PRODUCT CHANGE NOTIFICATION (PCN)

AMJE0909-0500-GNB-24
MODULAR CABLE

CHANGE NOTIFICATION: PCN 20220509_AMJE0909-0500-GNB-24

DESCRIPTION OF CHANGES:
CHANGE OF DATA SHEET
CHANGE OF DATA SHEET
New Draw.-No. ASS_7945_CArev02

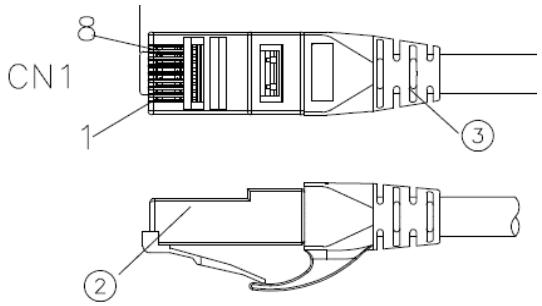
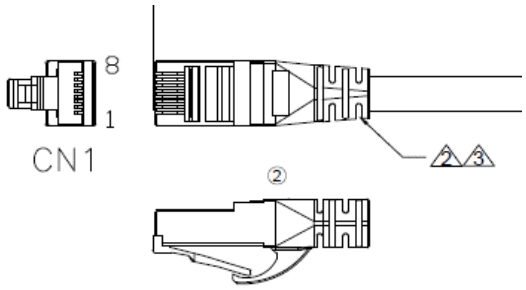
③	Molding	PVC 45P Color: see order code	NA	KG
②	CONNECTOR	RJ45 8P8C two fork Short type 3u" gold plated	2	PCS
①	CABLE	CAT6 UTP (24AWG*1PR)*4+PVC OD=5.8±0.3MM Color: see order code	NA	MM
NO:	NAME	DESCRIPTION	Q'TY	UNIT

3	Molding	PVC 65P Color: see order code ②	NA	KG
2	CONNECTOR	RJ45 8P8C PLUG 3u" gold plated ②	2	PCS
1	CABLE	CAT6 U/UTP (24AWG*1PR)*4+Cross+PVC Jacket OD=5.8± 0.3MM Color: see order code ②	NA	MM
NO:	NAME	DESCRIPTION	Q'TY	UNIT

Drawing-No.
ASS 7945 CA

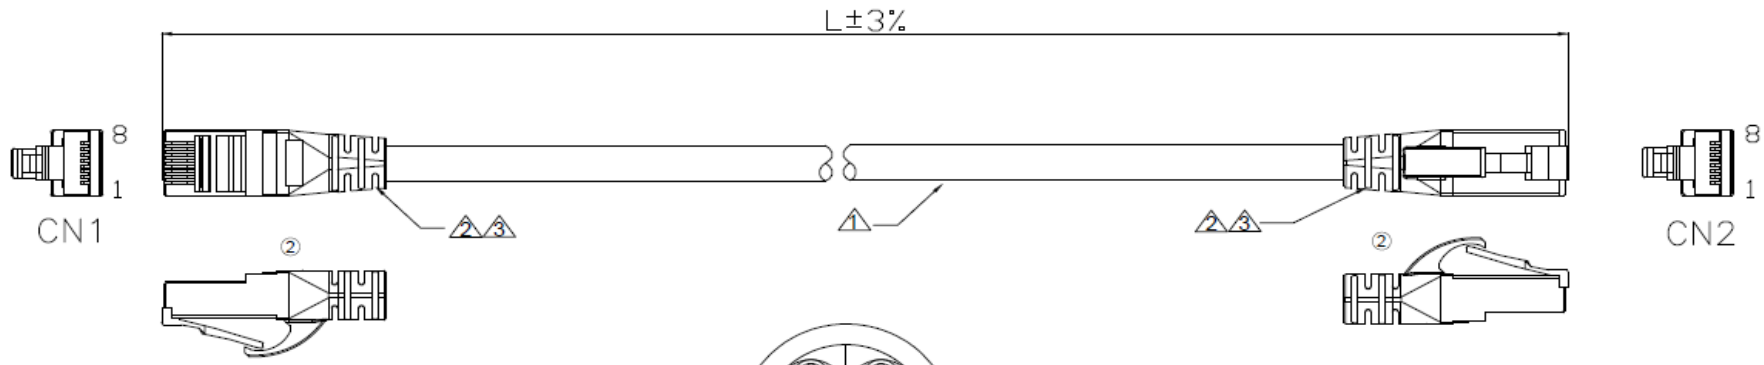
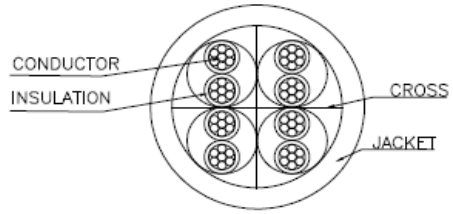
Id.	Modification	Date	Name
②	Change the plant	09.05.2022	Luca
①	Update the WSW order code	02.06.2017	Amy
⓪	Drawn	30.03.2017	Amy

NO:	NAME	DESCRIPTION	Q'TY	UNIT
3	Molding	PVC 65P Color: see order code ②	NA	KG
2	CONNECTOR	RJ45 8P8C PLUG 3u" gold plated ②	2	PCS
1	CABLE	CAT6 U/UTP (24AWG*1PR)*4+Cross+PVC Jacket OD=5.8± 0.3MM Color: see order code ②	NA	MM
